產品及製程變更通知

PCN No. : ZD-10405001

Subject: YS ZS47xxA Series lead Frame changed to SMF package..

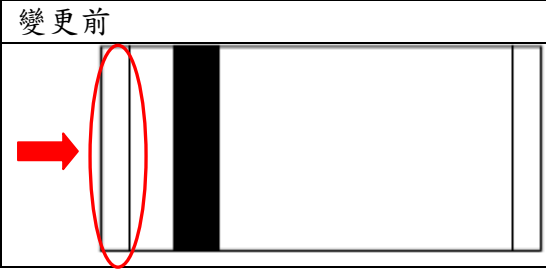
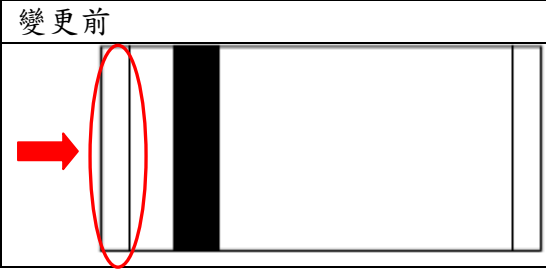
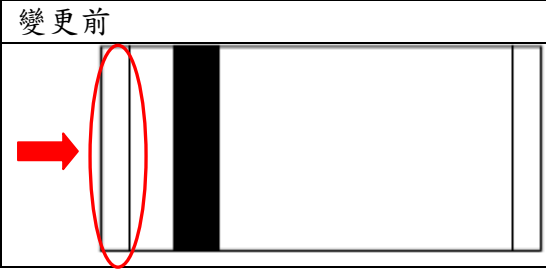
PCN 編號(PCN No.) : ZD-10405001	發行日期(Issue Date) : May 27, 2015				
主題 (Subject) : YS ZS47xxA Series lead Frame changed to SMF package.					
首次出貨日期(Proposed First shipping Date) :	July 1, 2015				
樣品有效日期(Samples Availability Date) :	June 27, 2015				
變更生效日期(Complete Date):	August, 26, 2015				
變更類型(Change Category) : <input checked="" type="checkbox"/> 材料 Material <input checked="" type="checkbox"/> 外觀 Form <input type="checkbox"/> 製程 Processing/Fit <input checked="" type="checkbox"/> 規格書 Datasheet <input checked="" type="checkbox"/> 設計 Design <input type="checkbox"/> 測試 Testing <input type="checkbox"/> 製造地點 Manufacturing Site <input type="checkbox"/> 品質/可靠性 Quality/Reliability <input type="checkbox"/> 包裝/運送/標籤 Packing/Shipping/Labeling <input type="checkbox"/> 其他 Other _____					
變更敘述(Description of change) : 1. Lead frame change, Modify tooling change and Modify the data sheet. The package difference as below:					
<table border="1" style="width: 100%;"> <tr> <td style="text-align: center;">變更前</td> <td style="text-align: center;">變更後</td> </tr> <tr> <td style="text-align: center;">  </td> <td style="text-align: center;">  </td> </tr> </table>		變更前	變更後		
變更前	變更後

2. The Part name will be changed to SMF package from SMA package.					
變更理由(Reason for Change) : 1. Improvement of lead frame stability and package size to obtain a more robust bonding process.					
產品辨識(Product Identification) : Outline (Lead frame)					
預期影響(Anticipated impact) : Layout pad will be different.					
影響的產品(Affected Product) : N/A					
品質驗證(Verification /Qualification) : N/A
